MAINE TURNPIKE AUTHORITY

ADDENDUM NO. 2

CONTRACT 2019.15

GRAY TRAVEL PLAZA
FUEL SYSTEM REPLACEMENT
MILE 58.8 NB

DRAINAGE PLAN

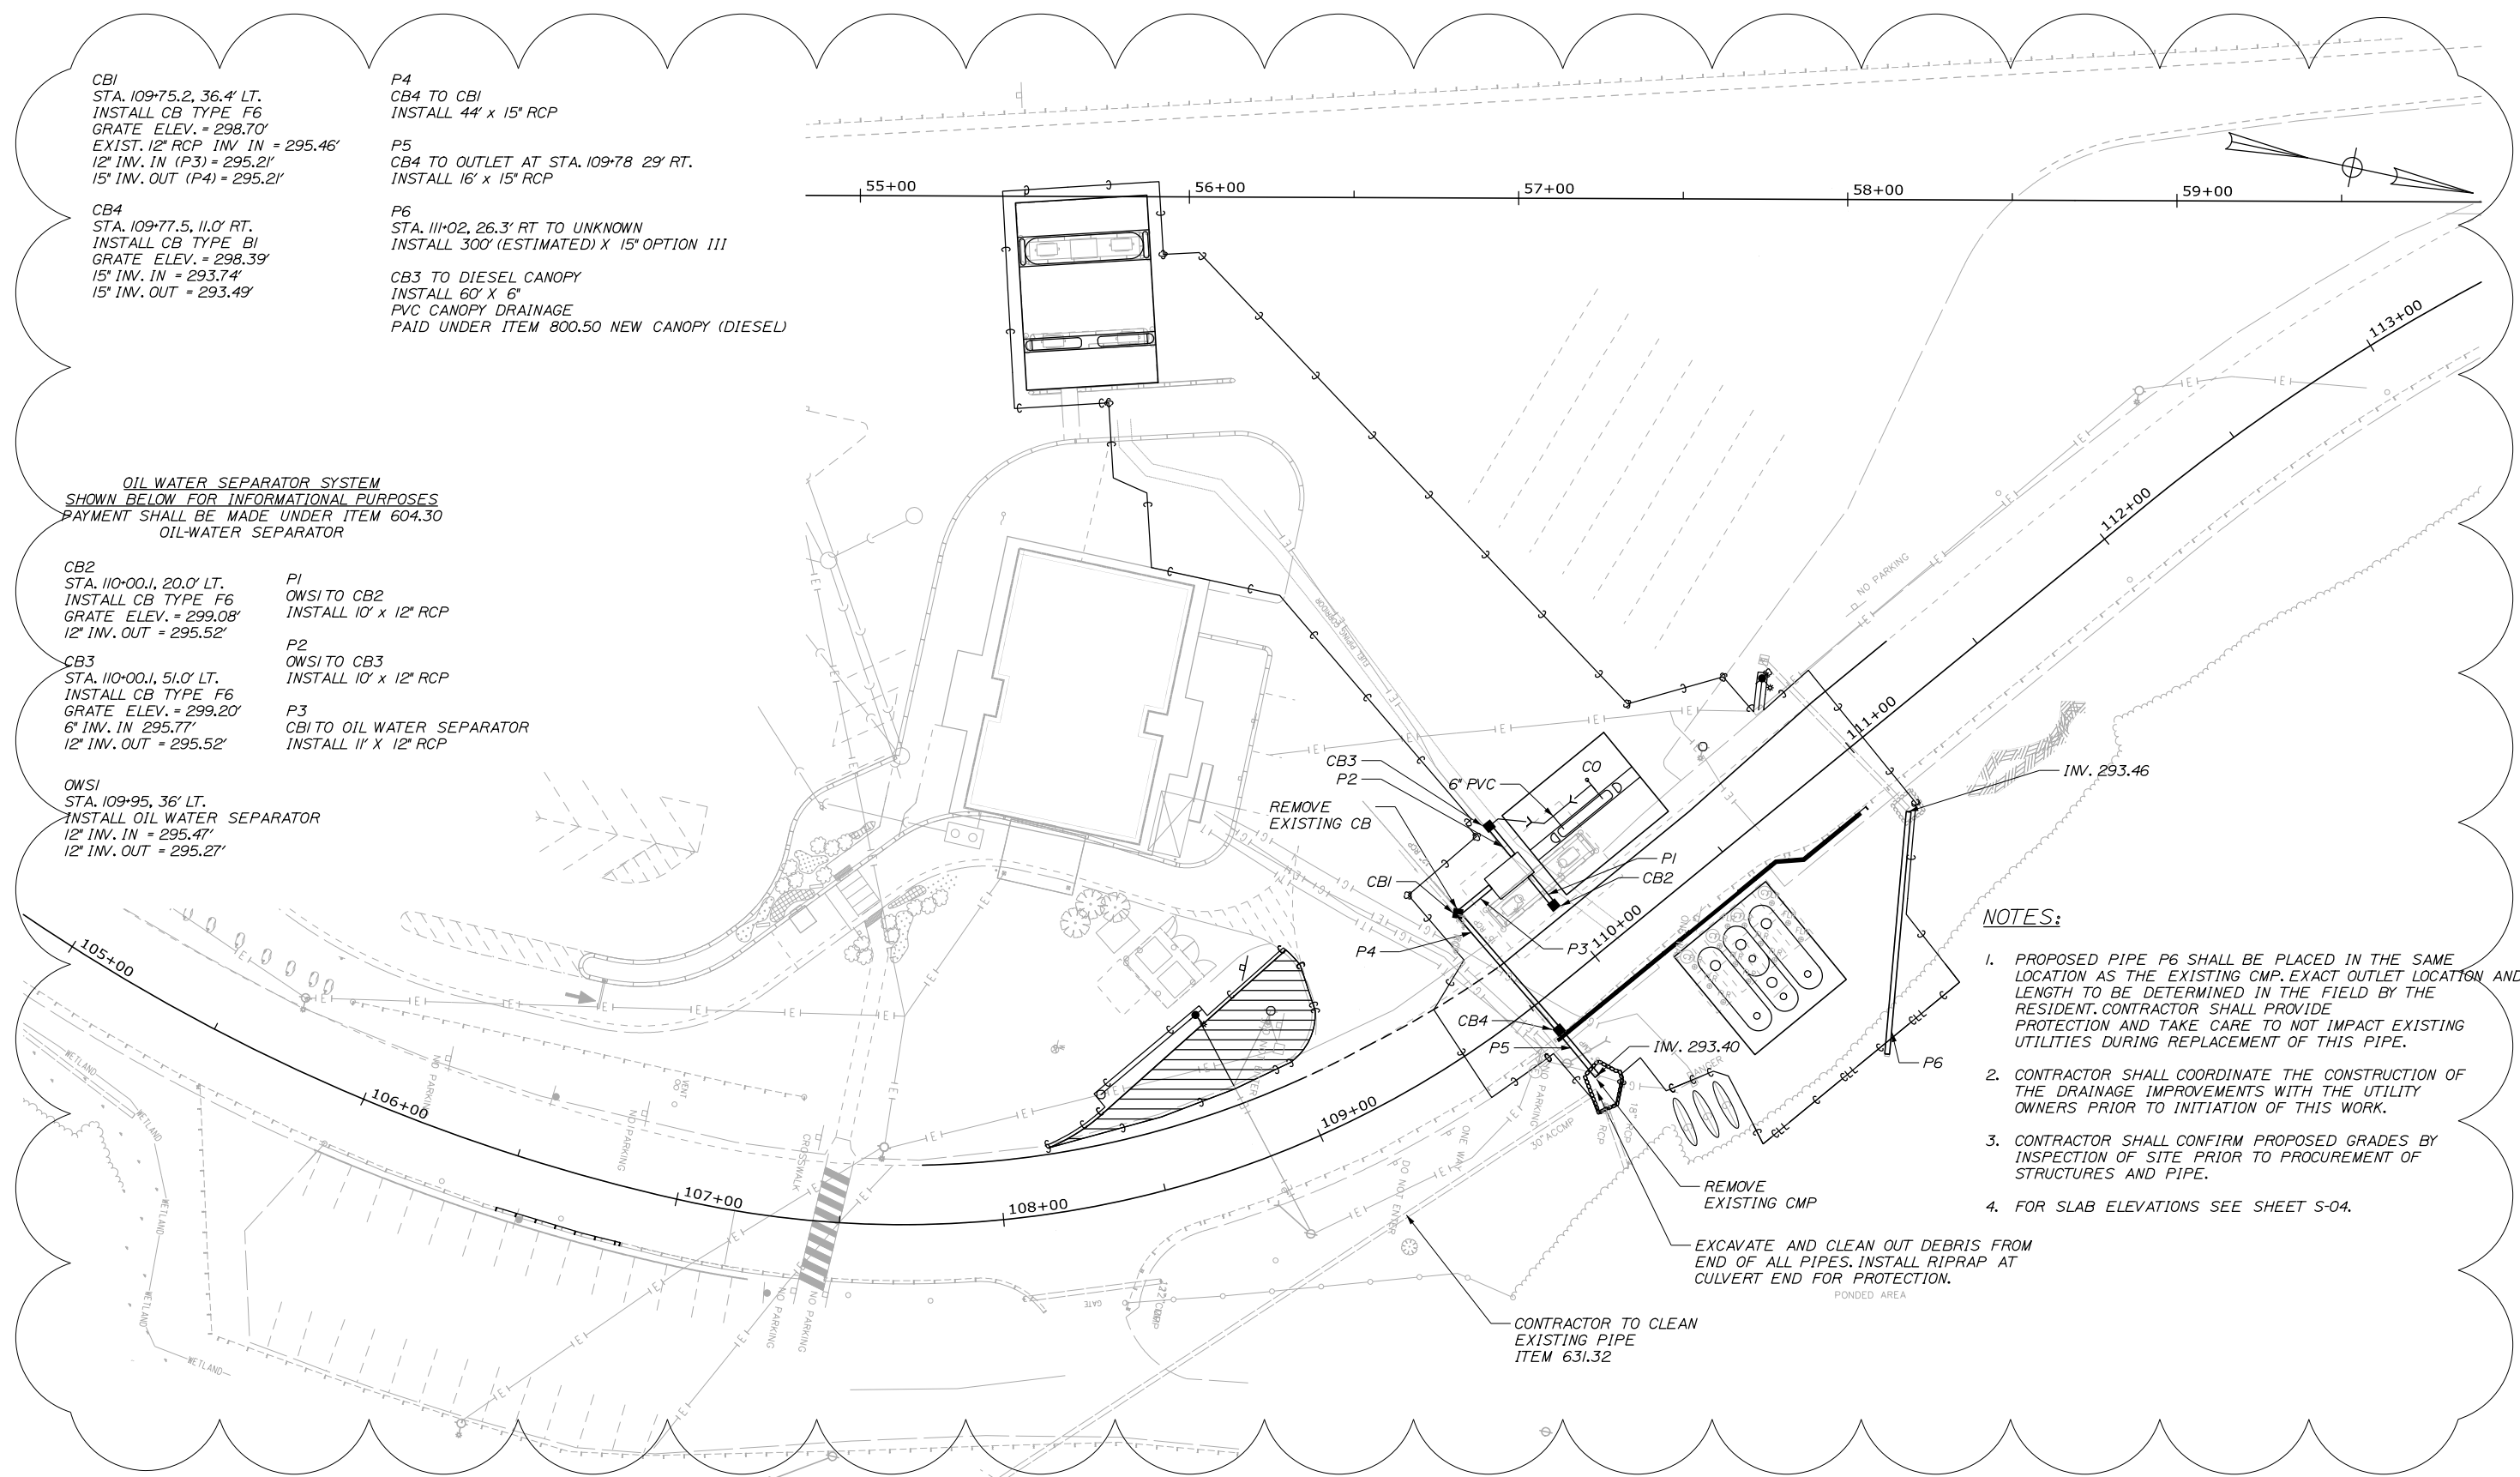
- 4) Can you clarify the components of the oil water separator?

No.	Revision	By	Date
1	REVISED DRAINAGE	DAM	7/19

Response: The Oil-Water Separator consists of the oil-water separator structure, two F-basins that collect oil and water from the diesel slab area, and connecting pipes, including the connection pipe from the oil-water separator to the first downstream catch basin, CB 1.

The plans have been modified with specific labeling of these components. This modification also changes the Bid Items.

GRAY SERVICE PLAZA
FUEL SYSTEM REPLACEMENT
CONCRETE SLAB AND ISLANDS
AT DIESEL DISPENSERS

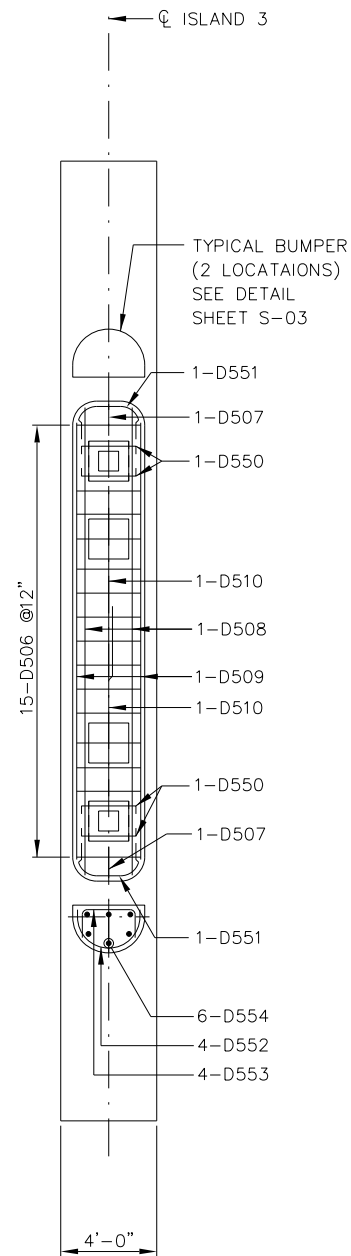
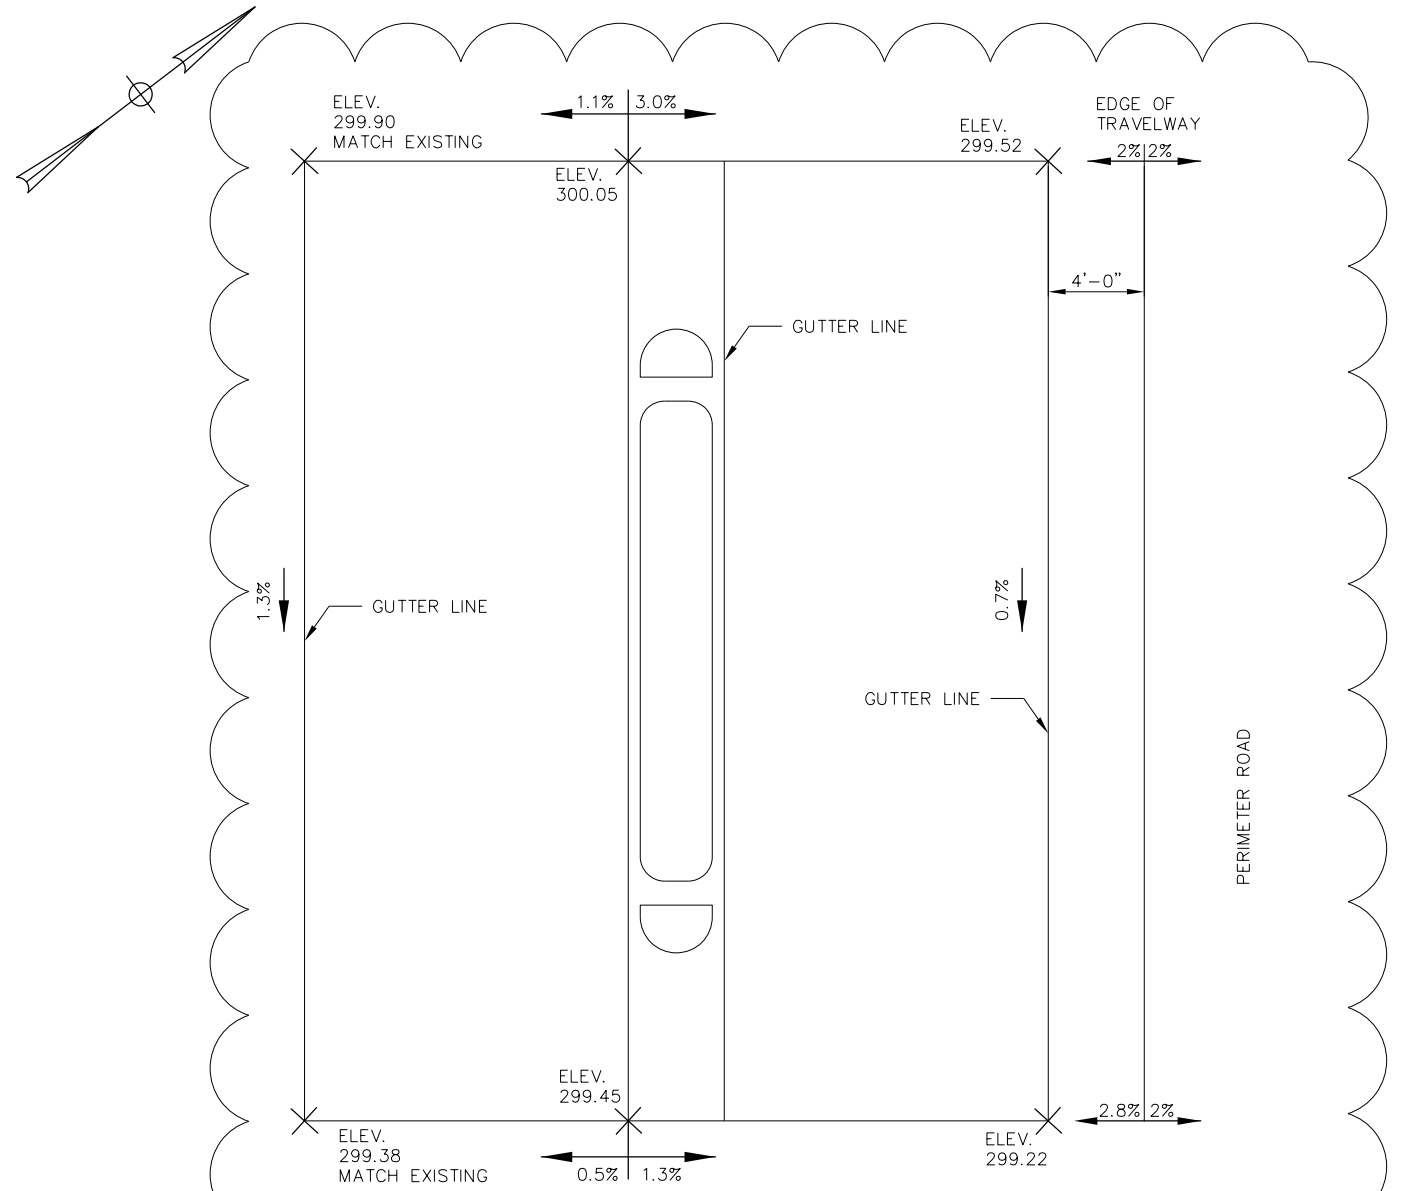
- 6) We could not find elevations of the dispenser pads or the tank pads on the plans. These elevations control the depth of the tank needed for the estimates.

Scale:				Designed by:			
AS NOTED							
No.	Revision	By	Date				
1	REVISED SLAB GRADING	DAM	7/19

Response: Additional grading and spot elevation detail is provided for the diesel dispensing slab and the portion of the perimeter road that will be excavated for tank removal and replacement.

1. CONTRACTOR SHALL FIELD VERIFY PROPOSED ELEVATIONS SHOWN ABOVE PRIOR TO CONSTRUCTION OF SLAB.
2. CONTRACTOR SHALL ENSURE THAT SLAB AND SURROUNDING AREA DRAINS TO CB2 AND CB3.
